KAMIRA AVENUE VILLAWOOD

RFI - URBAN DESIGN REPORT

JULY 2023

**KAMIRA AVENUE
VILLAWOOD STAGE 02**

CONNECTIVITY
RESIDENTIAL PEDESTRIAN MOVEMENT

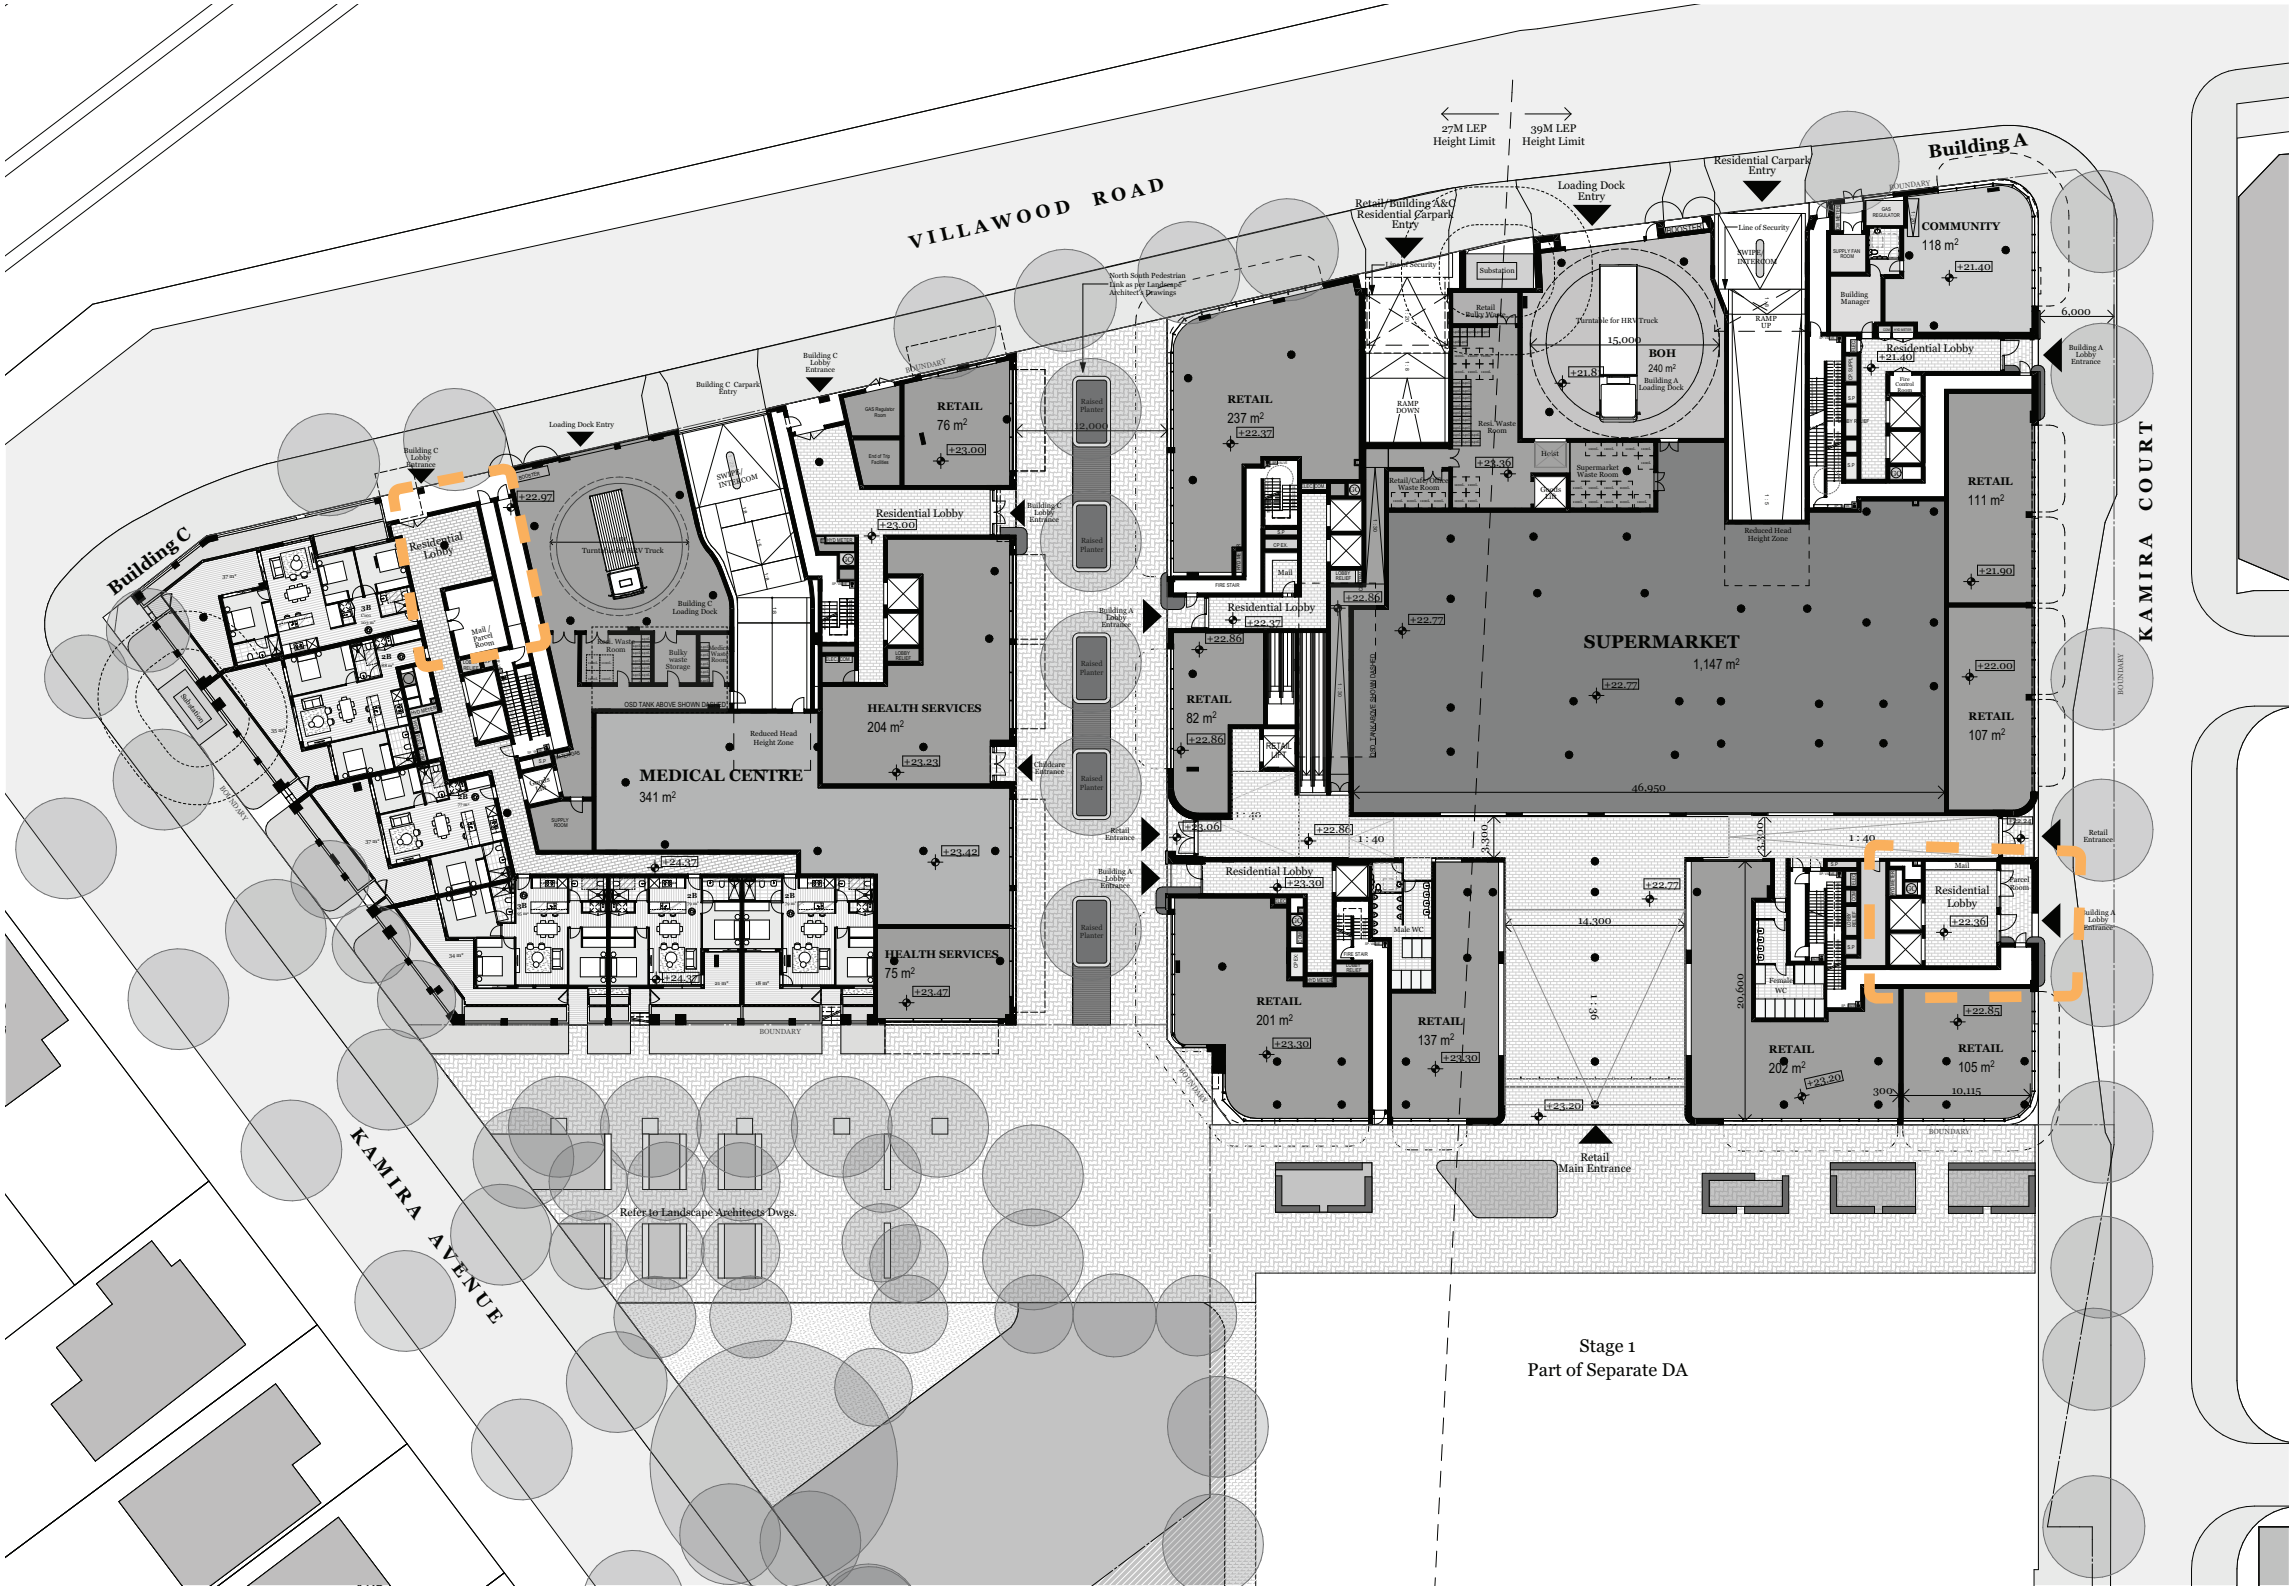
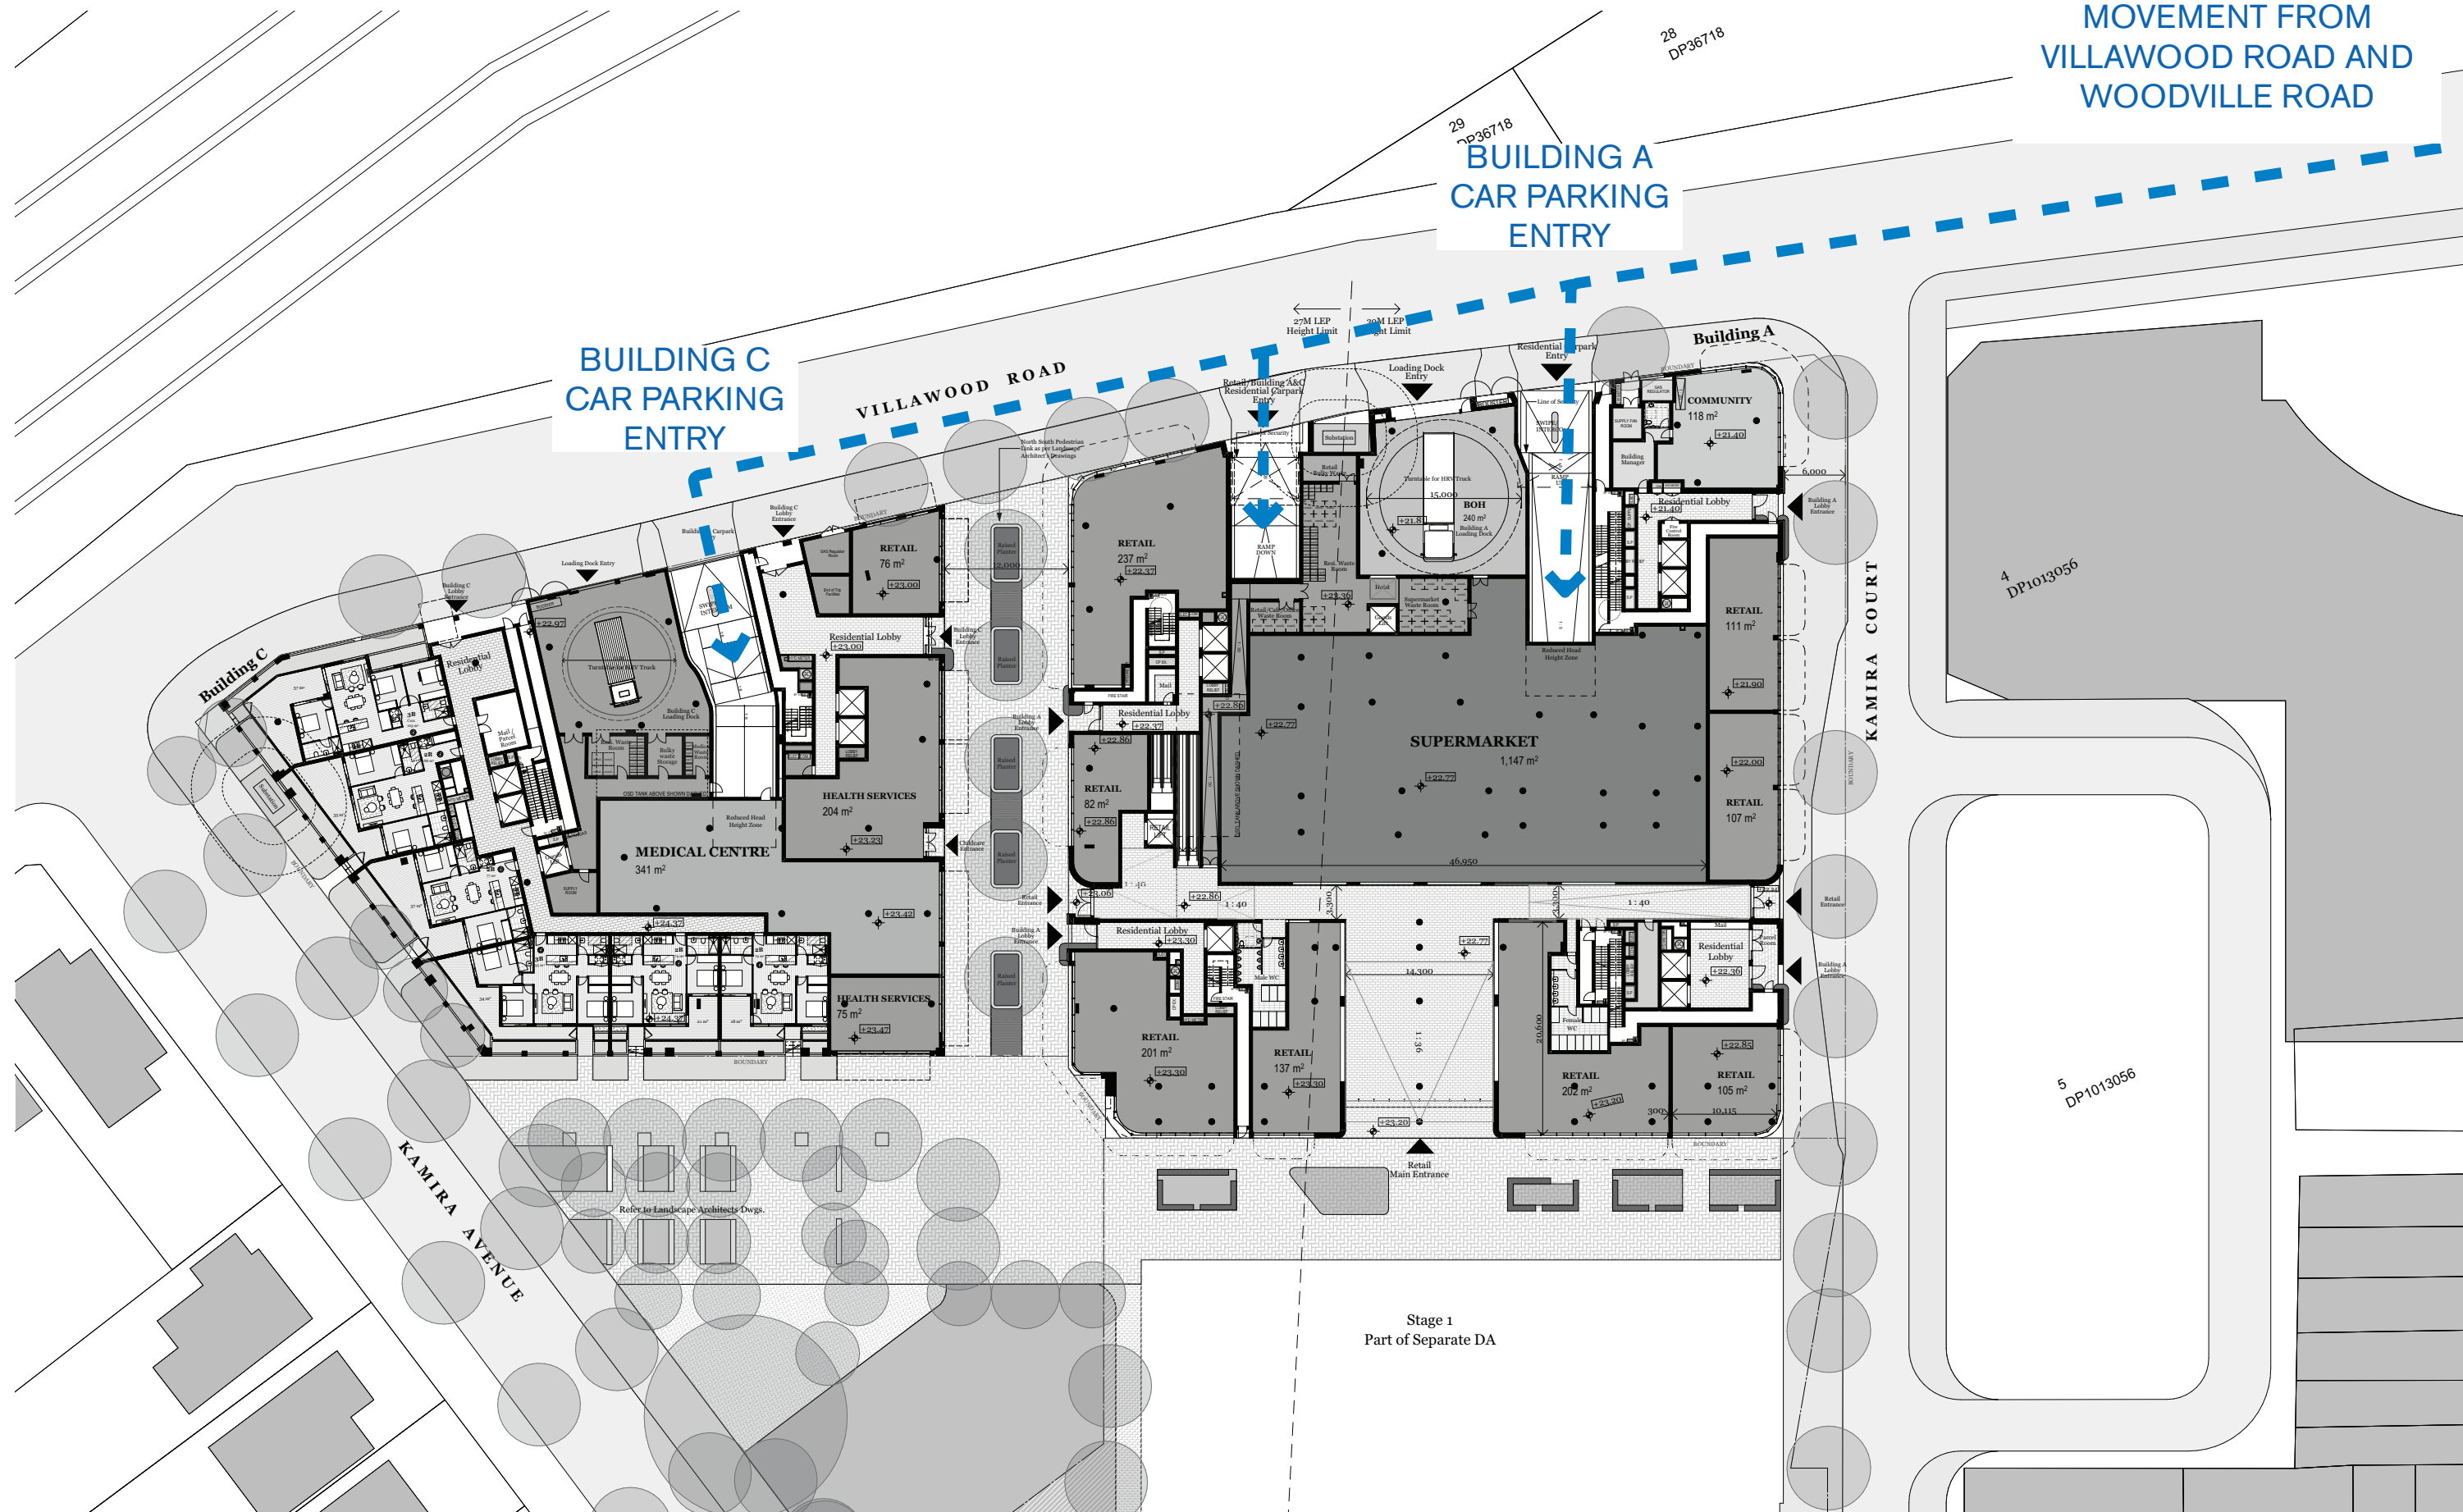
Wayfinding plans shall be submitted to show how different entries can be Accessed and the route to the mailboxes.

Locations are compliant with Australian Post Standards. The mailboxes are preferred to be located the mailbox in one main lobby which has been indicated.

BUILDING C SOUTH ELEVATION**Council Comments**

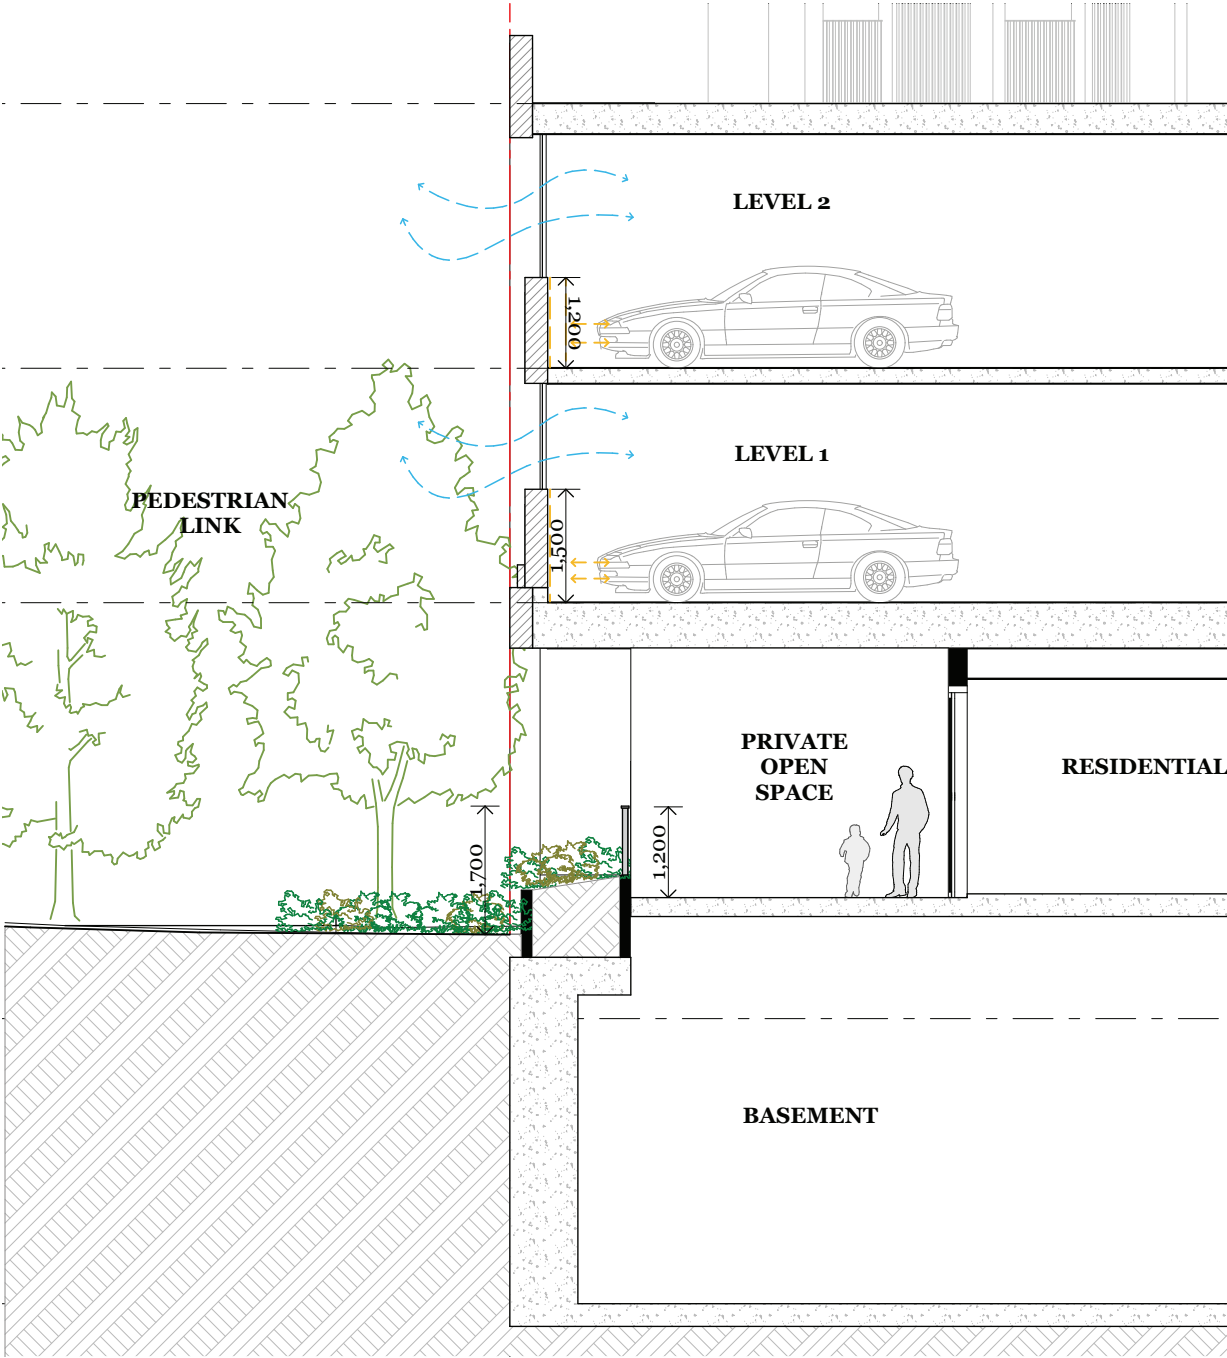
Building C (Western Block) could be improved to incorporate more grounded deep soil central zones to provide more access to light, ventilation and open space.

Remove the podium car park to provide greater landscaped areas, internal courtyard areas and reduce the bulk and scale/visual impacts from the extent of the podiums and add variety to design including definitive corner residential units with well-articulated corner, especially for Block C where the car park is located on south and western elevations.

Building C (Western Block) allows for deep planting zones with trees surrounded on western and south edge.

Introduction of residential units to the ground level provides activation to the main pedestrian links and Kamira ave and raked planters that provide visual softening the facade and privacy buffer to residents.
